memorandum

TO	Bruce Van Duyn	FROM	Eoghan O'Neill
	Carter Group Ltd	DATE	9 September 2026
RE	Wastewater – Beca Review Questions

Figure 2: Total Daily flows at Rangiora WWTP and Bradleys Rd.

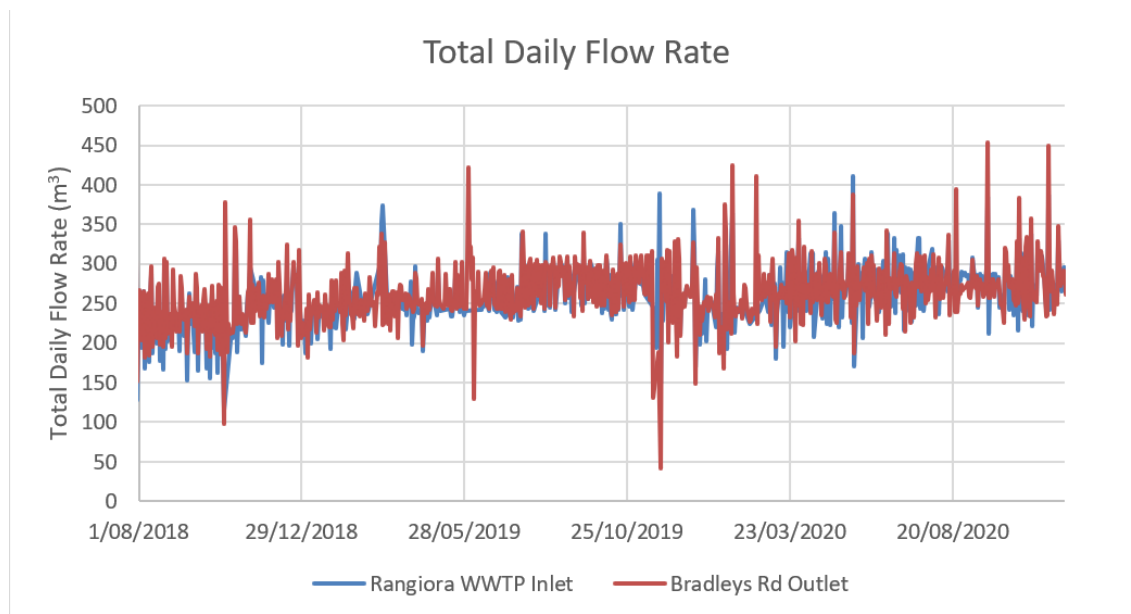
1.4 Please provide further information on how the 251m³ storage has been calculated

The analysis deliberately focussed on the period when very extreme flows were generated within the Mandeville wastewater network. These flows were driven by extended periods of surface flooding and ponding in the Mandeville area due to very high groundwater levels induced by successive large rainfall events. As the area relies on stormwater discharge via infiltration, the high groundwater levels impeded discharge to ground and resulted in ponding across the area. This ponding directly affected the Mandeville STEP (Septic Tank Effluent Pumping) network, with septic tanks on properties receiving direct inflows of surface water and high rates of groundwater infiltration which were then pumped through to the BRPS. The analysed period is therefore considered to represent a worst-case scenario and includes the largest inflows to the Bradleys Road pump station since at least 2018, and likely since the June 2014 storm event that caused extensive flooding in the area. Figure 2 below is sourced from the Waimakariri DC report entitled Mandeville Area Wastewater Network Model, dated 13 August 2021, and indicates inflows to BRPS from 2018 to 2020.

For context, the peak inflow to the Bradleys Rd PS during the two-week focus period of analysis was 1,720 m³/day. The storage proposed would only be needed during an event of similar magnitude and would be unused for the balance of the time. Over the two-week period analysed, wastewater was only accumulating and being stored within the tank for a consecutive period of 89 hours (3.7 days) during the peak of the inflow event at Bradleys Rd PS. During this time, the wastewater was also regularly pumped out of the storage tank, which greatly limited the residence time of the wastewater in the tank. Over the 89-hour period during which the peak wastewater volume of 251 m³ accumulated within the storage tank, a total volume of 2,406 m³ was pumped out of the same tank. The peak hydraulic retention time calculated for wastewater within the storage tank over the 89-hour accumulation and discharge period was 15.5 hours, and the average hydraulic retention time over that period was 6.75 hours.

Figure A1 Instant Valve Closure (0.1 s) and Opening (0.1 s) at time of 10 s and 150 s. Pump Remains on.

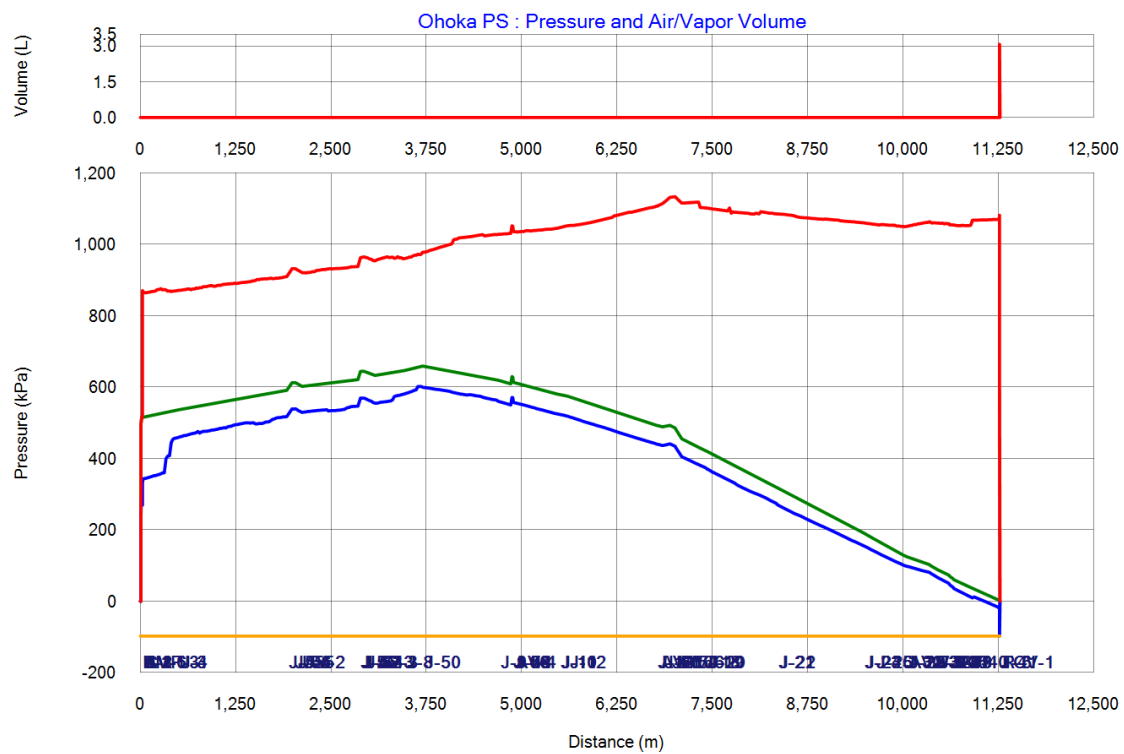
1.3 What water hammer calculations have been completed for a fast valve closure on the pumping main?

Four valve closing scenarios were undertaken using the Bentley Hammer model software for the OPS operating at a flow of 30 L/s. These scenarios were:

- ✧ Instant Valve Closure (0.1 s) and Opening (0.1 s) at time of 10 s and 150 s. Pump Remains on.
- ✧ Fast Valve Closure and Opening (10 s). Pump remains on.
- ✧ Fast Valve Closure and Slow Opening (10 s / 150 s) - with pump ramping down in parallel
- ✧ Fast Valve Closing and Opening (10 s) - with pump ramping down slowly after closure/open of valve.

The pressure profile results generated for these scenarios are appended in Appendix A. For all modelled scenarios, the maximum pressure remained within the pressure class of the pipeline. The scenarios are not exhaustive, and additional transient modelling will be completed at detailed design stage to confirm any positive or negative pressure mitigation measures required for the final pump station and rising main configuration.
